Advisory Action Before the Filing of an Appeal Brief	Application No. 10/082,479	Applicant(s) GIAMPAVOLO, PAUL	
	Examiner Korie H. Chan	Art Unit 3632

THE REPLY FILED 05 October 2007 FAILS TO PLACE THIS APPLICATION IN CONDITION FOR ALLOWANCE.

Examiner's Illustration of Prior Art reference to Artemis

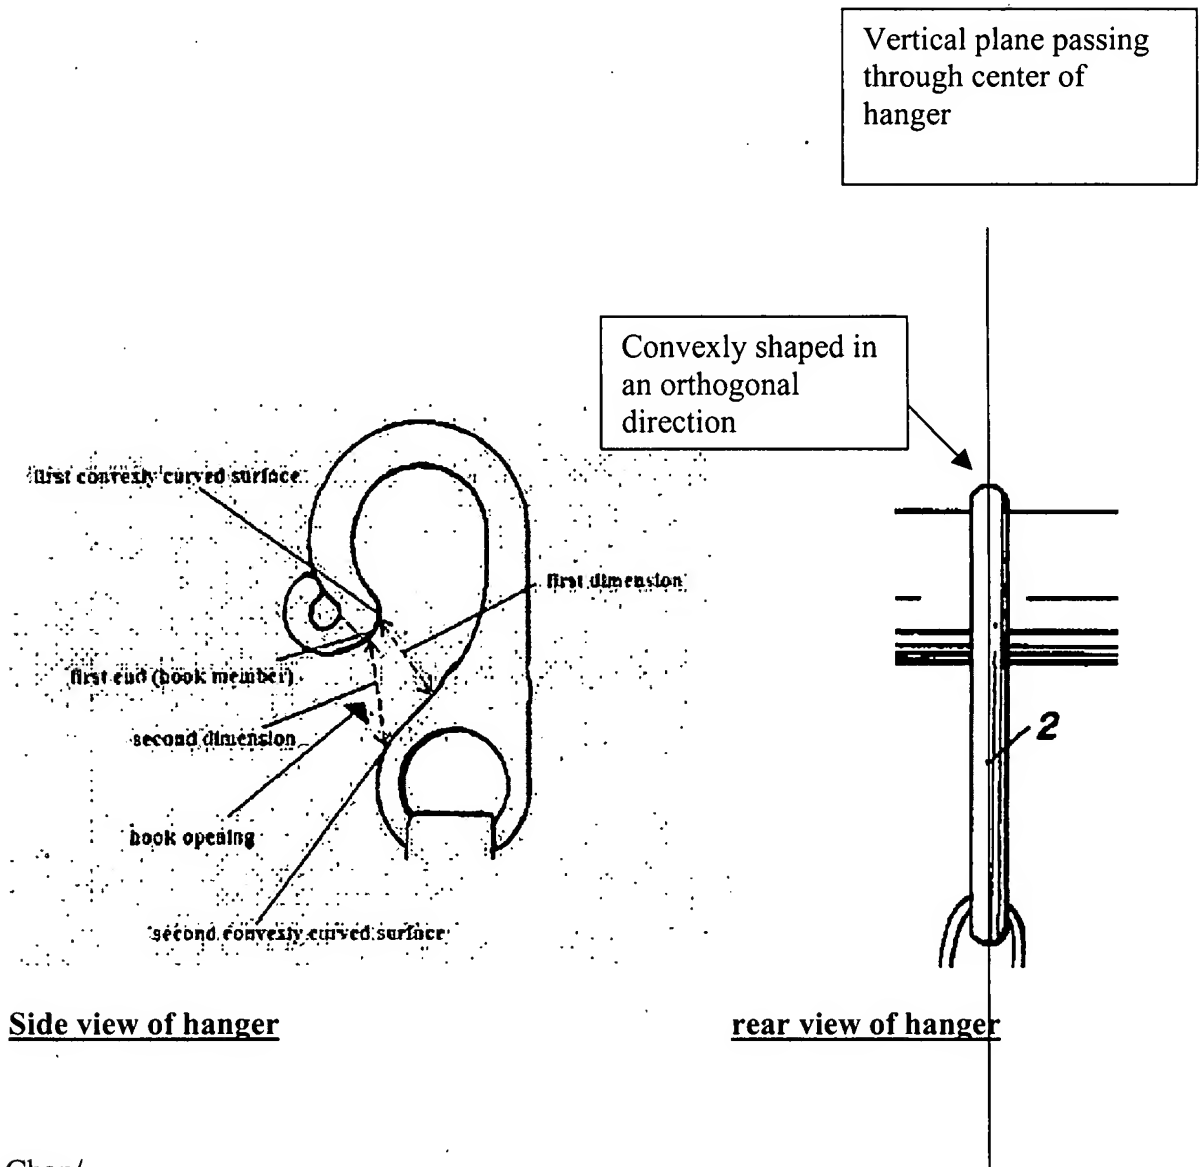
Applicant's argument that "there is a vertical plane of the hook-shaped member that passes through a center of said extended hook region surface, the center of said body portion surface and the center of said rod retaining surface. Further, each of the independent claims recites that the extended hook region surface is convexly shaped in a direction orthogonal to said vertical plane and wherein the body portion surface is convexly shaped in the direction orthogonal to the vertical plane", Artemis does not that the vertical plane (as seen in figure 6) would be a plane of the paper that extends through a center of the extended hook region surface, the center of the body portion surface and the center of the rod retaining device. And as seen best view in figure 4, Artemis's hanger is of generally round or circular cross-section. The limitation that the extended hook region surface is convexly shaped in a direction orthogonal to such vertical plane as discussed above; and wherein the body portion surface is also convexly shaped in the direction orthogonal to such vertical plane (see attached illustration).
